## SERVICE LETTER 285

### FIRE BOSS FWD HYDRAULIC ACCESS

| <b>Aircraft Makes/Model(s):</b> | <b>Float Model(s):</b> | <b>Compliance:</b> Optional | <b>By:</b> MAS       |
| Air Tractor                     | 10000A                 | <b>Part Number:</b> 1013260 | <b>Approved:</b> DRH |

**Figure 1 – Installation Overview**

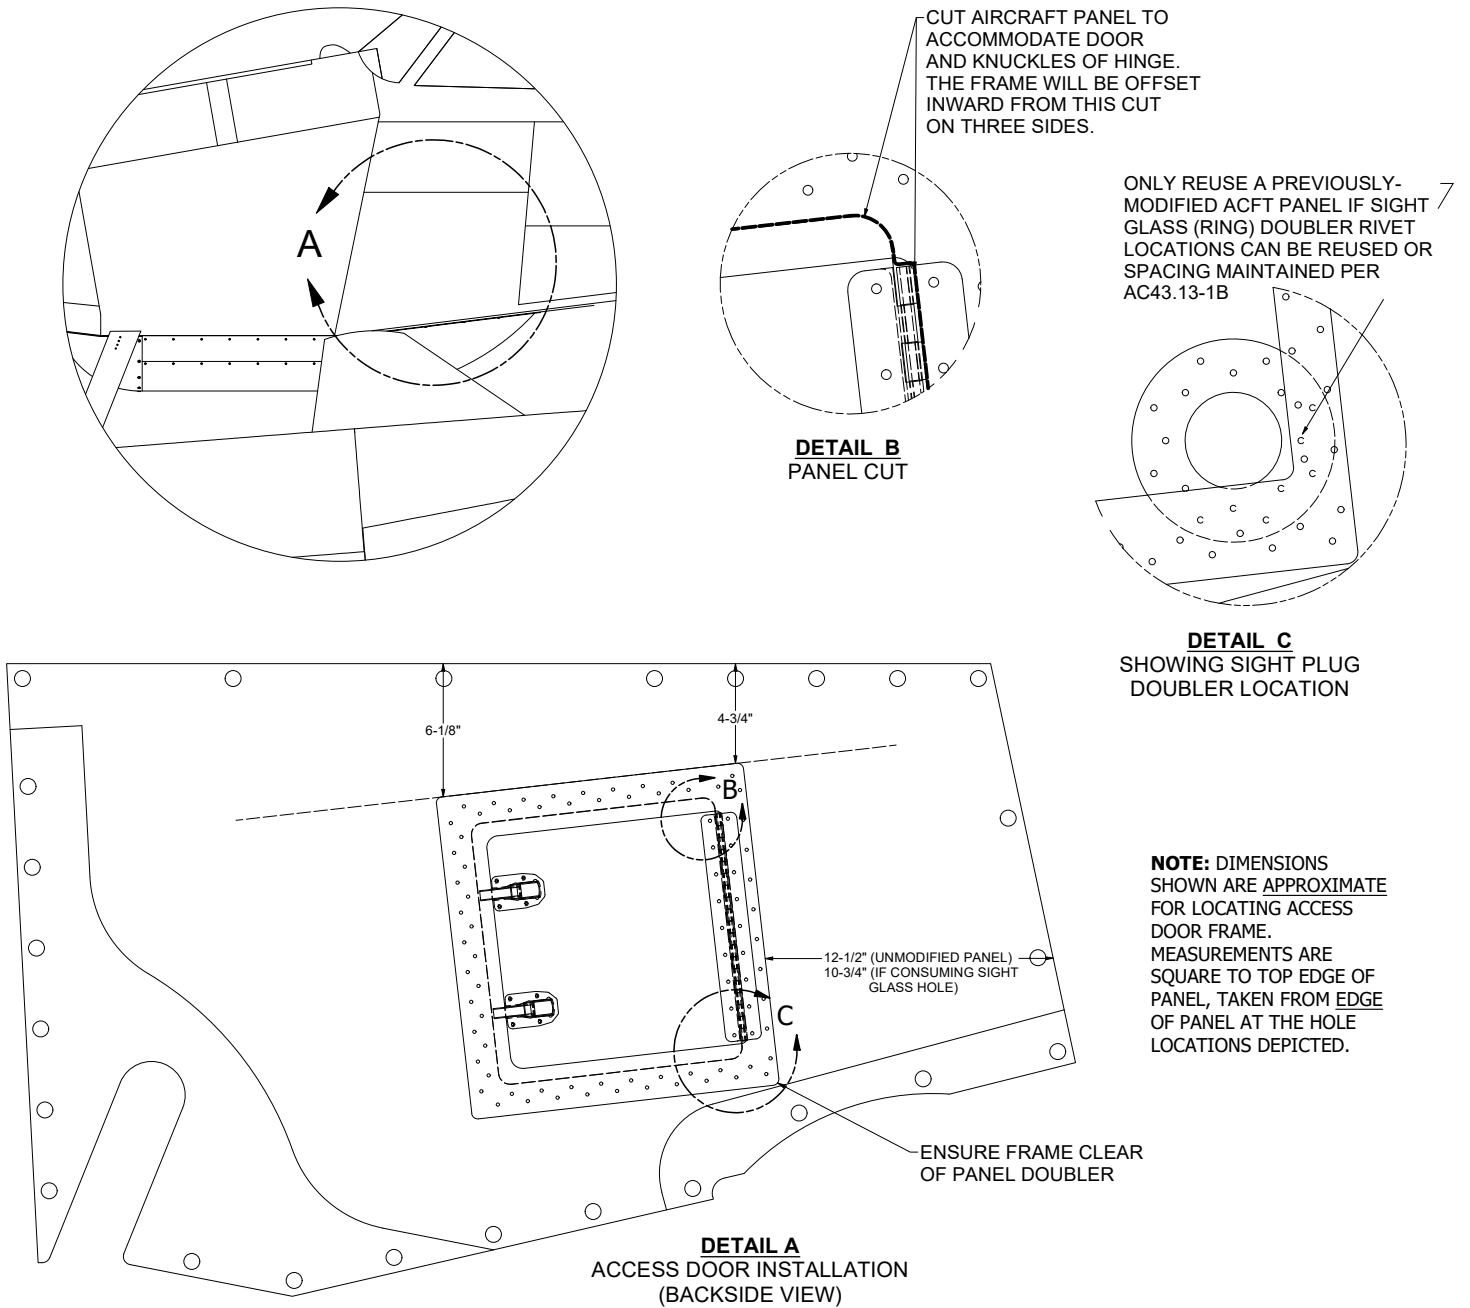
The relocation of the hydraulic power pack to fuselage station 67.88 was originally accompanied by a sight plug installed in the left/lower cockpit side skin panel. The sight plug offered limited visibility and required removal of the full panel in order to access/service the power pack. This service letter describes installing a latched access door in its place.

3. Modify aircraft panel:
  - a. Locate access door frame on panel according to the approximate dimensions shown in Figure 1.
    - i. As indicated in Figure 1, a slightly more aft position is preferred for general access reasons but a forward-shifted position is likely needed to consume the sight plug cutout, if present.

- ii. The narrower edge of the frame mates to the door hinge and is to be located forward on the panel.
    - iii. If reusing an aircraft panel that was previously modified for the Wipaire sight plug, confirm existing rivet locations will not conflict with frame installation – holes may be reused or must maintain proper spacing per AC43.13-1B

- b. Match drill rivet holes (#4 rivets) into aircraft panel.
  - c. Align access door assembly using hinge rivet locations, then mark the cut to be made in the panel. The cut must accommodate the door plus the knuckles of the hinge. The inner edges of the frame will be offset inward on three sides of this cut.
